**SEISMIC/TORNADO ANALYSIS REVIEW  
FOR THE VITRIFICATION FACILITY  
AT WEST VALLEY**

**Nuclear Regulatory Commission  
Contract NRC-02-88-005**

**Center for Nuclear Waste Regulatory Analyses  
San Antonio, Texas**

**April 1993**

Figure 3-3. VF stick model used by Dames & Moore (Gates, 1993)

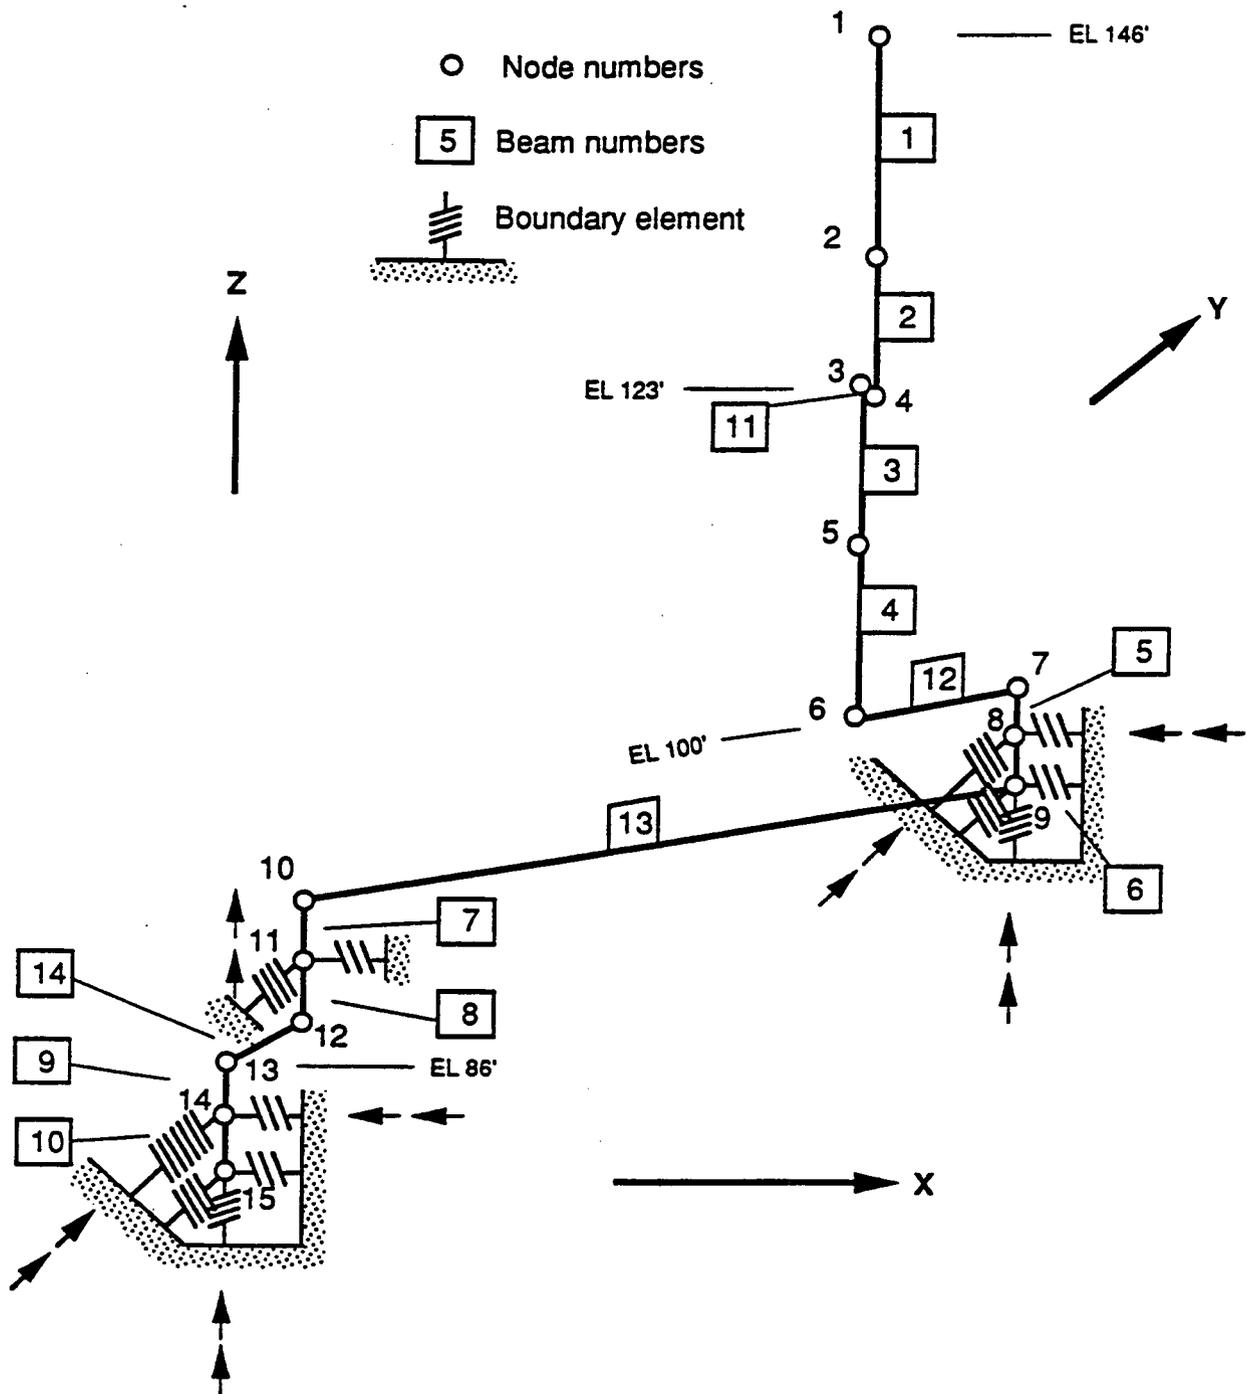
The alternative procedure used in the original analysis, and that performed by Dames & Moore (Gates, 1989b), is to idealize the soils utilizing boundary elements consisting of springs and dampers. For the 3D stick model (Figure 3-3), boundary elements were used at three different physical locations. At two of the locations, boundary elements are placed at different elevations to account for embedment of the foundation. The source of the values used in determination of the stiffness and damping values used in this model are not given. It appears that they are based on the simplified approaches similar to those given by Das (1983), Novak (1974), and Veletsos and Meek (1974). From the discussions given in the various documents, it is not apparent whether a linear or nonlinear boundary element was utilized.

(Figure 3-3). The results presented are in terms of modal frequencies, peak displacements at various locations, elevated response spectra, and the forces and stress in the elements. The response spectra indicate a primary response of 5 to 7 Hz, corresponding to the first natural frequency of the VF cell. Under earthquake loading, the margins of safety for structural yield or failure range from 3 to 6, except for the roof hatch, for which the margin of safety was 1.5. Reduction of the soil damping from 20 percent to 10 or 15 percent could lower these by as much as a factor of 2. This could result in margins of safety less than 1.0. Therefore, resolution of the soil damping values is critical for resolution of this open issue.

For the VF primary structure using the 3D FEA stick model (Figure 3-3), results were presented in Gates (1993). Results are in terms of modal frequencies, peak displacements at various locations, elevated response spectra, and forces and strains in the elements. The response spectra indicate a primary response at 5 to 7 Hz, corresponding to the first natural frequency of the VF cell, which is consistent with reinforced concrete structures of this geometry.

Figure 3-4. Dames & Moore FEA model of reprocessing plant guyed stack (Gates, 1993)

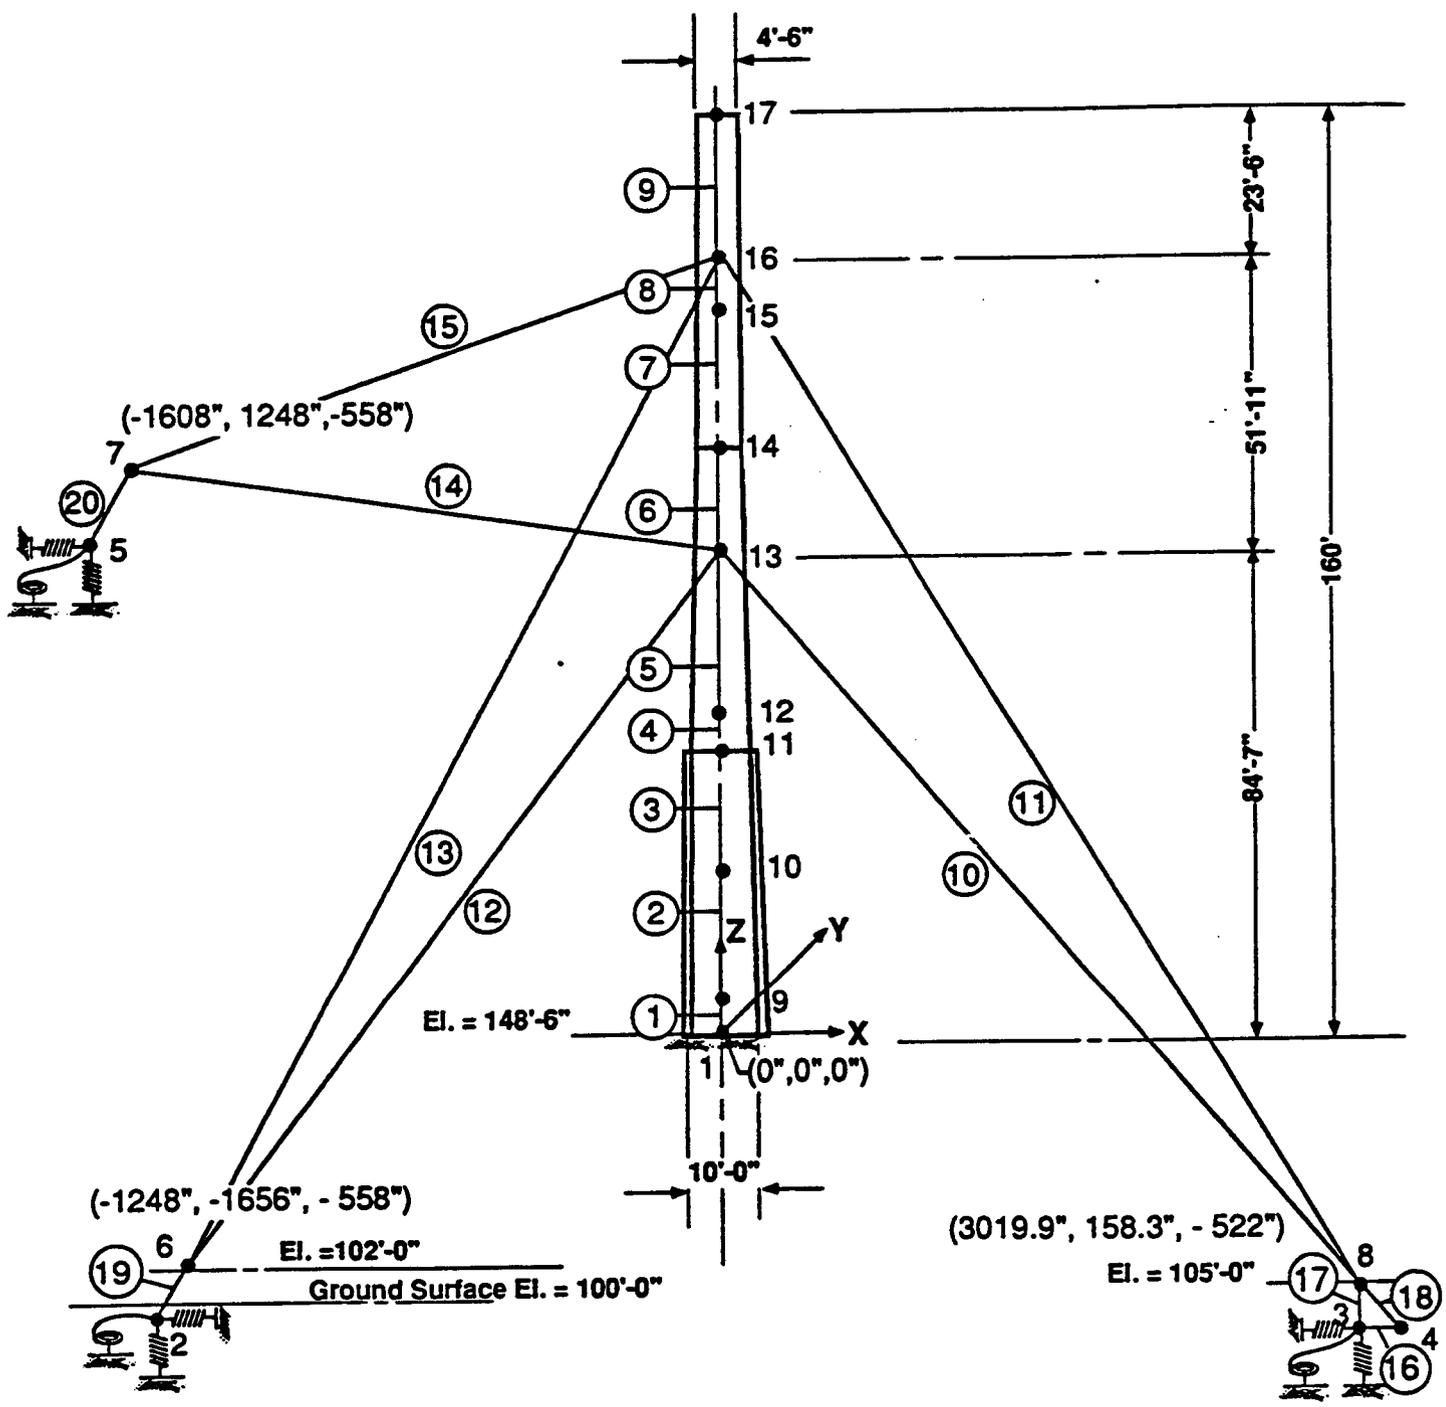
In the modeling of the stack, it was assumed that the base was fully restrained. For a slender system of this type, it is difficult to obtain a moment restraint at the base, even with the expanded diameter and the addition of gunite to the lower portion of the stack. Realistically, the first mode of the system will be below the calculated 2.34 Hz when the base compliance is taken into account. The best way to verify the model is to take field measurements under ambient vibrations to determine the lowest modes. For this analysis, a 3D FEA beam model was utilized (Figure 3-4).

The response spectra used to define the input into the stack was based on an earlier analysis of the Reprocessing Plant and is dominated by the resonant response of the stack. By matching the calculated first mode of the stack to the stack base response spectra, the current model of the stack is forced to correspond in frequency to the earlier model. The net effect is to produce a conservative analysis.

The behavior of the existing 160-ft Reprocessing Plant Ventilation Stack (Figures 3-4 and 4-2) was analyzed under extreme environmental loads that include wind, tornado, and earthquake. The intent of the study was to realistically assess the collapse potential of the stack and the risk that such collapse might pose to the VF. Even if this failure were to occur, the possibility of any damage to the VF is remote. Although the resulting margins of safety are given, no calculations are shown supporting these. It would be appropriate to obtain some measured data on the dynamic characteristics of the stack, as well as major elements in the VF, for verification of the analytical models.

Figure 3-6. FEA of canister storage racks and waste header guide used by Dames & Moore (Gates, 1993)

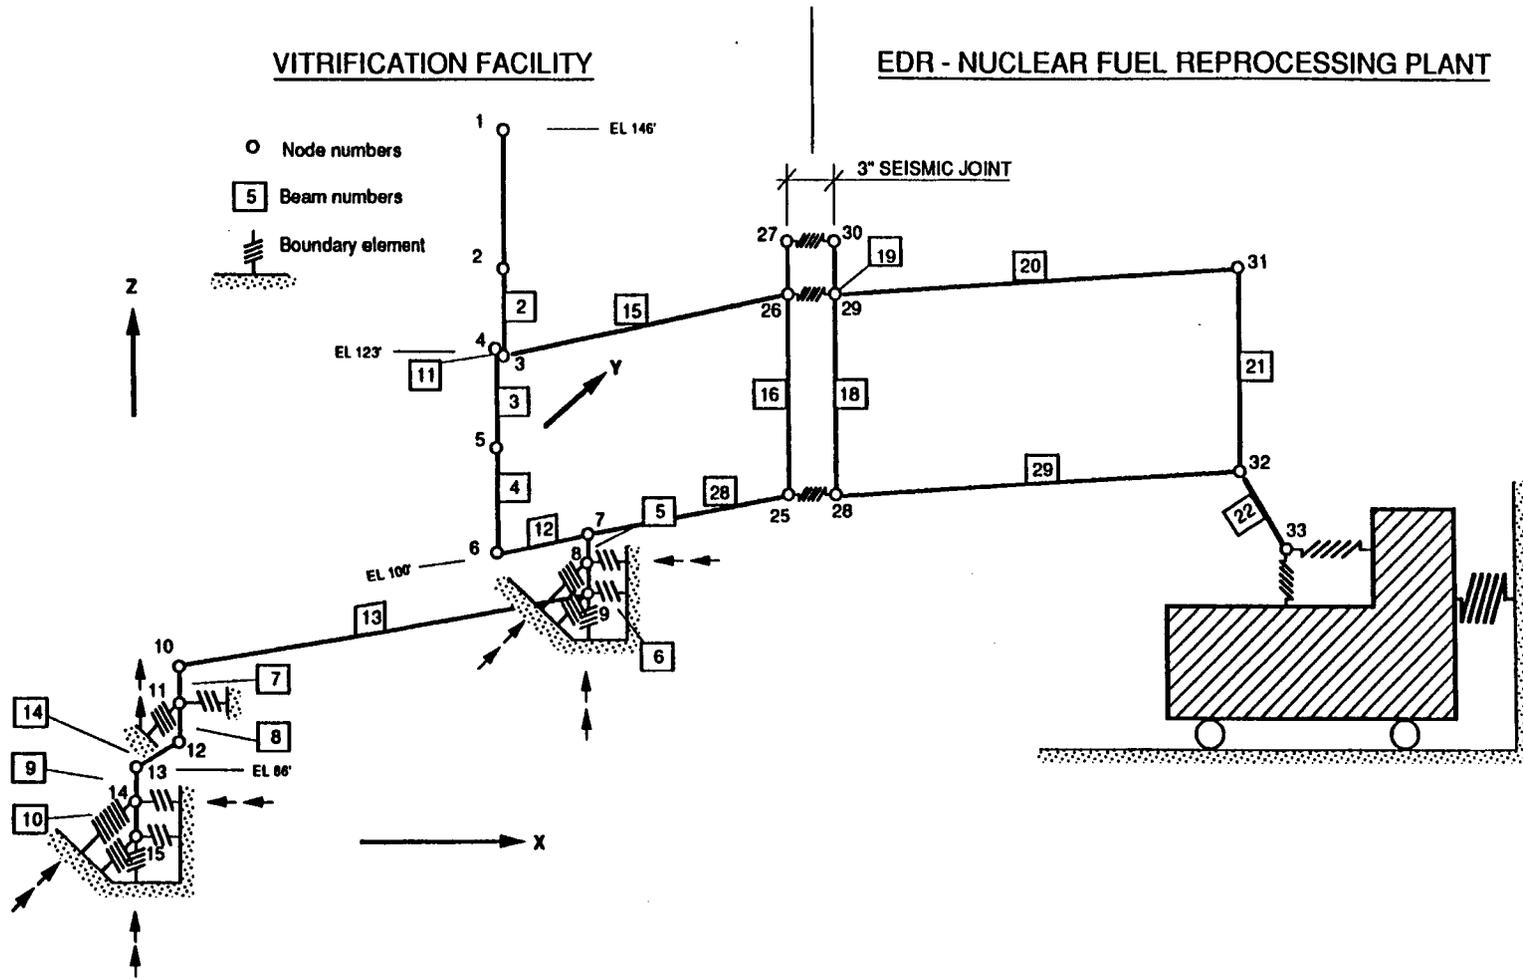
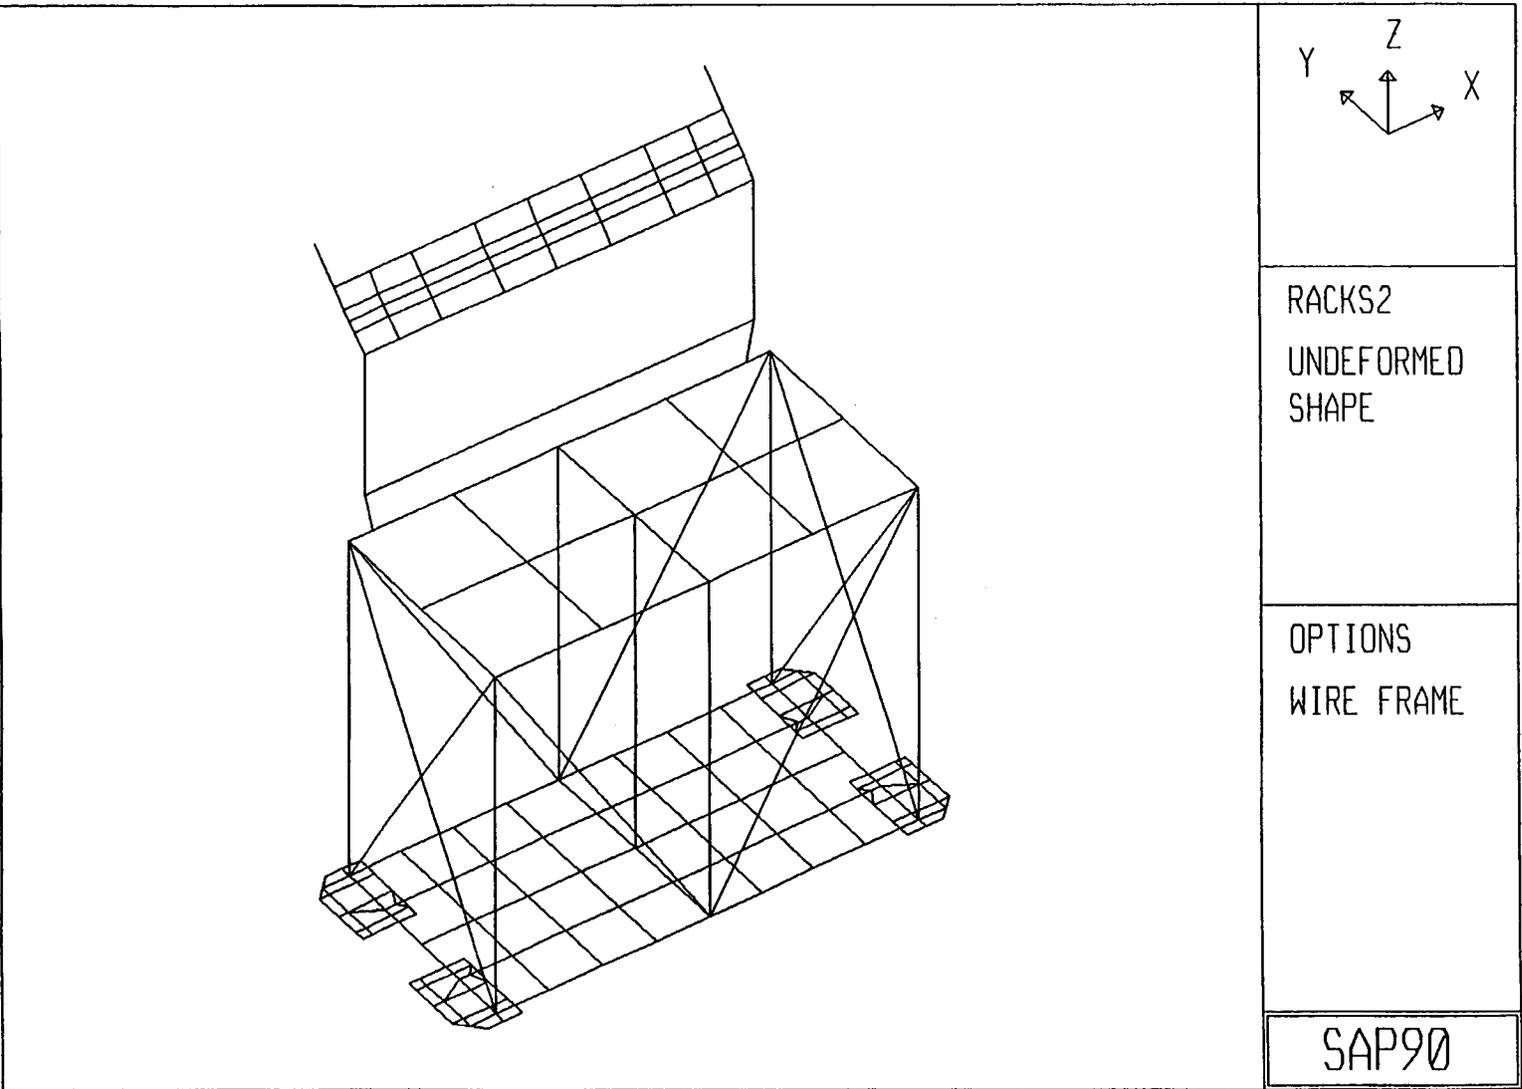
- Melter Supports (Overview with no results),
- Canister Storage Rack and Waste Header Guard (Overview with mode shapes. Stress ratios less than 0.66) Figure 3-6
- Overhead Coolers (Overview with no results)
- Overhead Cranes (Verbal indication of possible uplift)
- HVAC System (Overview of system)

Figure 4-1. Geometry of the shield windows (Gates, 1993)

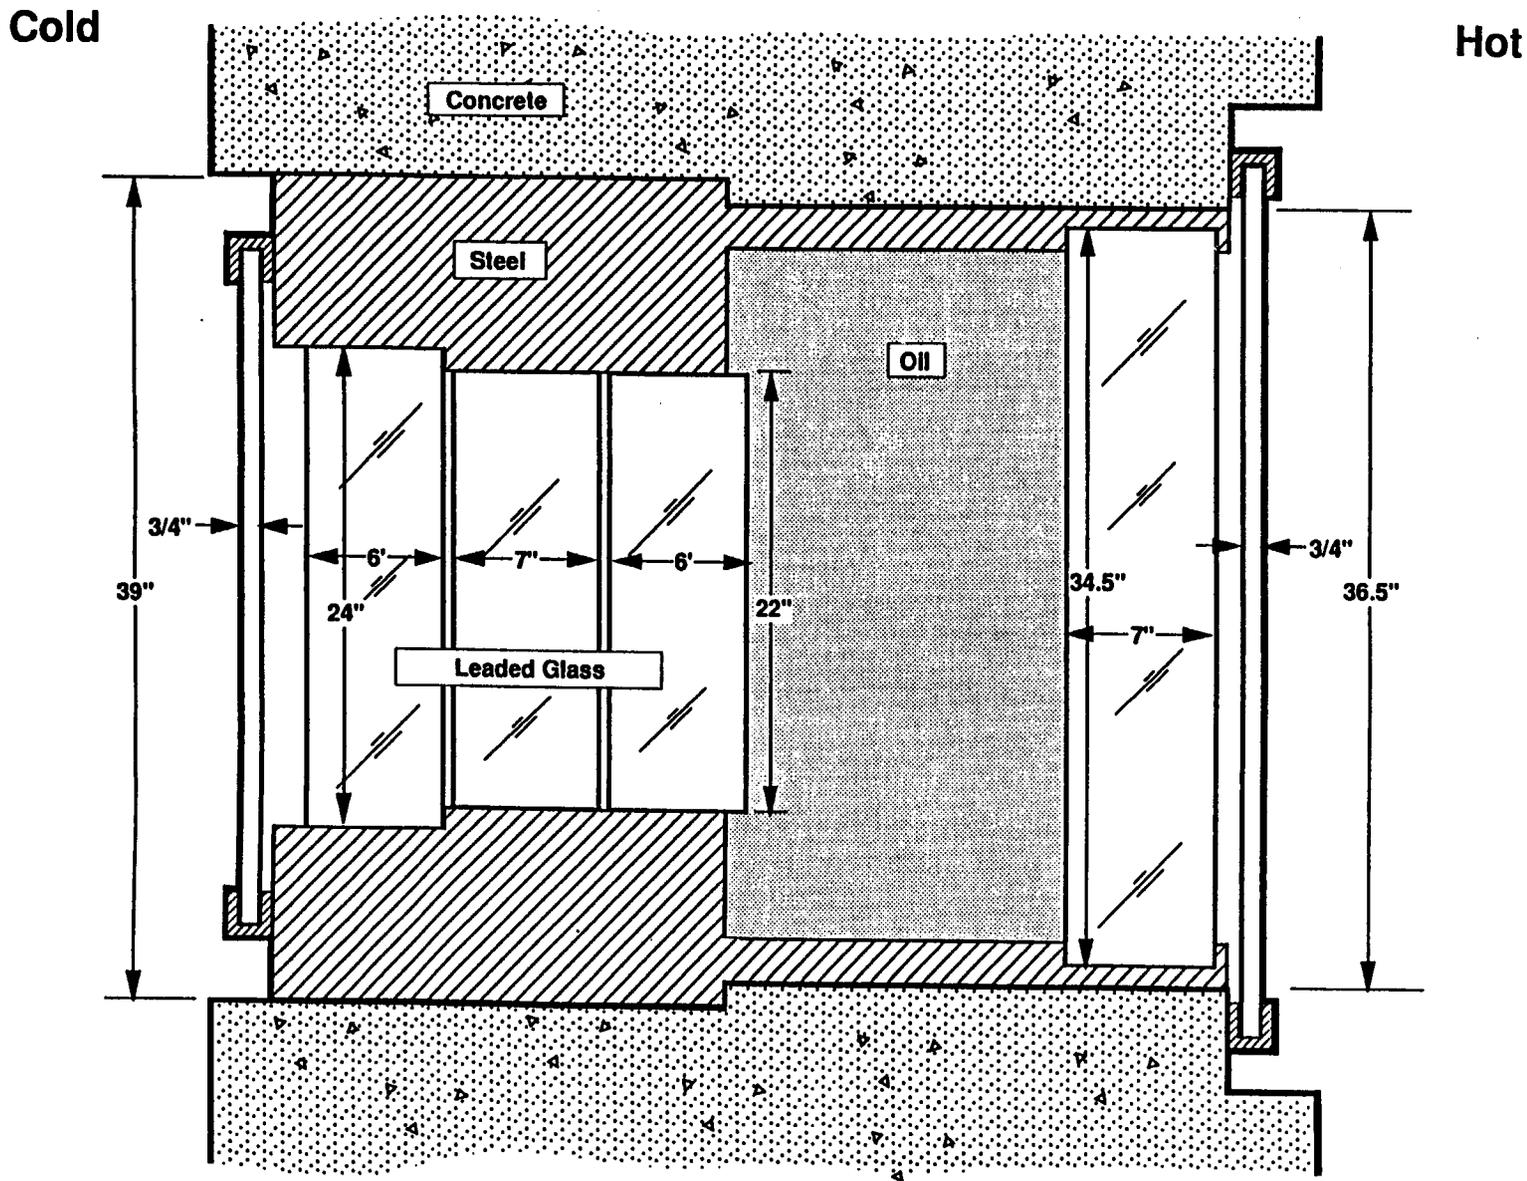
The shield windows are considered a weak element in the primary passive containment system when subjected to impact by a tornado-driven missile. The basic geometry of the window is shown in Figure 4-1. It consists of multiple layers of leaded glass supported in

For the shield windows, the approach taken was to assume that penetration did occur and determine the level of leakage. If the leakage rate was acceptable then the design was considered to be acceptable. This procedure was discussed in detail in Section 4.
